## **ATTACHMENT 6**

### **CORRESPONDENCE RECEIVED**

**Re: Comments to the City of Pleasanton's, Housing Site Development Standards and Design Guidelines, Discussion Draft, April 2, 2012**

RE: Comments on Housing Site Development Standards and Design Guidelines, Discussion Draft, April 2, 2012

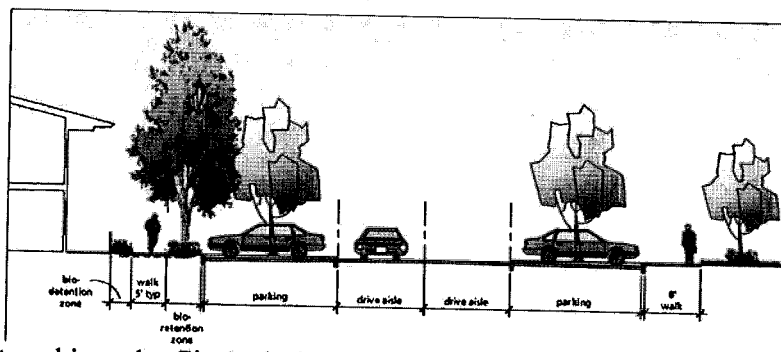
2. *Design Guideline A1.b - Alleys and parking areas should not be used for primary circulation to the building entries and through the site. Primary entries should not orient to alleys or parking areas.*
- Design Guideline A2.b - Building fronts should include porches and door entries facing streets and open spaces.*

***Design Guideline A1.b - Alleys without sidewalks should not be used for primary circulation to the building entries and through the site. No more than 15% of primary unit entries should orient to alleys without sidewalks or parking areas.***

***Design Guideline A2.b - When appropriate due to grade and adjacent use considerations, a minimum of 75% of building fronts should include porches or patio door entries facing streets and open spaces.***

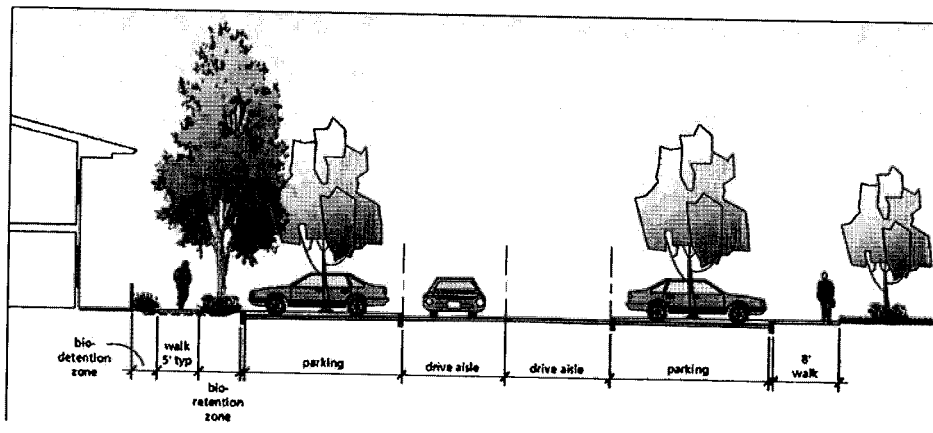
In order to achieve the City's desired density goals on these rezoned infill sites, there will be instances when home entries need to be aligned along alleys and or parking zones.

Carriage homes above ground floor garages are a building type that can be used to achieve desired densities while offering a variety of residential unit configurations and types that are desirable to the market place.

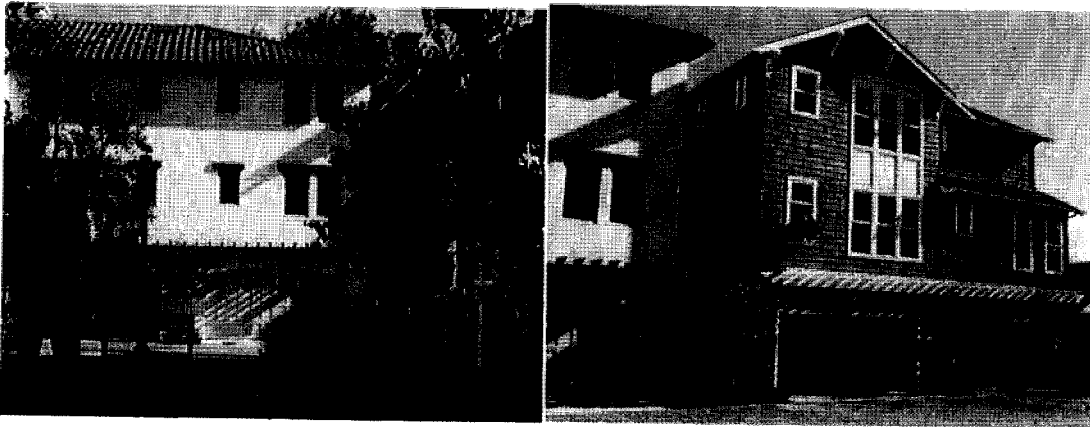
4. *Design Guideline A5.a - Garage doors should be recessed at least 2 feet from building façade.*

Specifying a 2 foot minimum recessed depth for garage doors creates the condition where the garage must be effectively 2 feet deeper to accommodate the recess, which may impact the ability to meet the 30 DUA density. A strong architectural presence can be achieved by recessing garage doors from the building façade less than 2 feet, providing architectural elements that protrude from the building façade, or additional architectural detailing. The building height also impacts the elevation. Examples of how an interesting elevation can be achieved without recessing the garage door a full two feet are shown below.

***Design Guideline A5 - Garage doors should be recessed from building façades or architectural elements should be incorporated into the elevation.***

### A4. Internal Streets and Drives

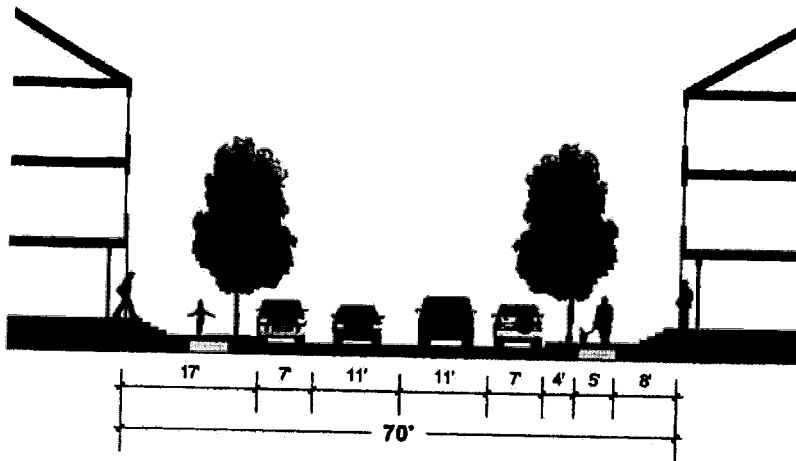
We find the majority of the design standards and guidelines in the July 11, 2012 draft to be generally workable. However, proposed guideline A4, Internal Streets and Drives, would serve as a strong barrier that would prevent development at the minimum density of 30 units per acre. Therefore, we respectfully request the City's revision of Guideline A4 to allow double loaded head-in parking on internal streets and drives, at least on triangular shaped sites.

Internal streets are more suitable for rectangular parcels that can accommodate a grid network as shown in the "Site Circulation and Building Orientation Diagrams." Specifically for Site 7, requiring "internal streets" would render a 30 DU/Acre development and its associated parking infeasible, especially given the triangular shape of the Site.

Furthermore, the proposed guideline A4 would run afoul of California Government Code Section 65589.5(d), which provides that a local agency shall not "condition approval [of a project] in a manner that renders the project infeasible for development for the use of very low, low-, or moderate-income households." Our project would come under the protection of Section 65589.5(d). Guideline A4 as now written would render our project infeasible, so we ask that it be removed, modified as requested above, or made not applicable to Site 7.
